Three Mile Island, Unit 1 (TMI Unit 1)
Facility Operating License No. DPR-50
NRC Docket No. 50-289

Subject: Response To Request For Additional Information –
Technical Specification Change Request No. 331: Application for Technical
Specification Improvement Regarding Steam Generator Tube Integrity
(TAC No. MD1807)

**RESPONSE TO REQUEST FOR ADDITIONAL INFORMATION
TECHNICAL SPECIFICATION CHANGE REQUEST No. 331
APPLICATION FOR TECHNICAL SPECIFICATION IMPROVEMENT REGARDING
STEAM GENERATOR TUBE INTEGRITY**

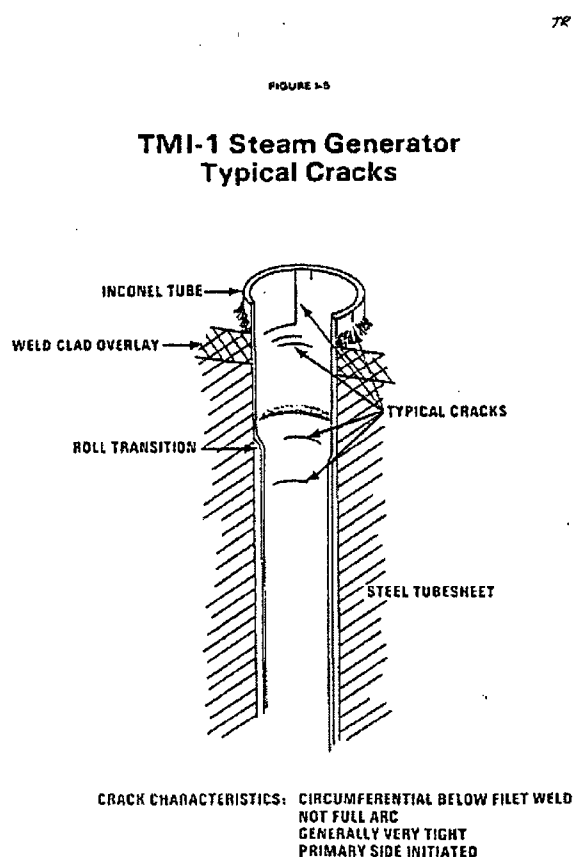
You provided references to support your position that you do not need to propose inspection and repair criteria for the parent tube behind the upper sleeve joints. The staff reviewed these references and they do not appear to support your conclusion that the staff accepted this position when we reviewed the engineering report addressing the criteria for kinetic expansion indications. As a result, discuss your plans for performing inspections of the upper sleeve joint area (including the parent tube) to confirm that you are operating the sleeve in accordance with its original design criteria (in terms of the state of the parent tube). In addition, provide the technical basis for this design criteria.

The proposed TMI Unit 1 Technical Specifications have been revised to include inspections of the parent tube in the upper tubesheet sleeve roll joint area to determine if parent tube degradation is occurring.

When sleeve upper tubesheet roll joints are examined, the associated parent tube will be examined using +Point MRPC probes using EPRI qualified techniques. These techniques are qualified for the detection of OD IGA and OD IGA/SCC in the parent tube. The acceptance criteria for the parent tube will be based on a comparison of the current outage's data and the earliest available historical +Point data for that tube. The qualitative comparison will address the following attributes of the parent tubing behind sleeve upper roll expansions:

- 1) Determine that the parent tubing is still present.
- 2) Determine if there is any change in the number of indications present.
- 3) Verify there is no change in the orientation/morphology of the indications
- 4) Verify there is no significant change in the circumferential extents of the circumferential and volumetric flaws.
- 5) Verify there is no significant change in the axial extents of the axial and volumetric flaws.

If the comparison of the data indicates ongoing degradation, that sleeved tube will be removed from service. This inspection scope and criteria has been added to proposed TS Section 6.19.c.3
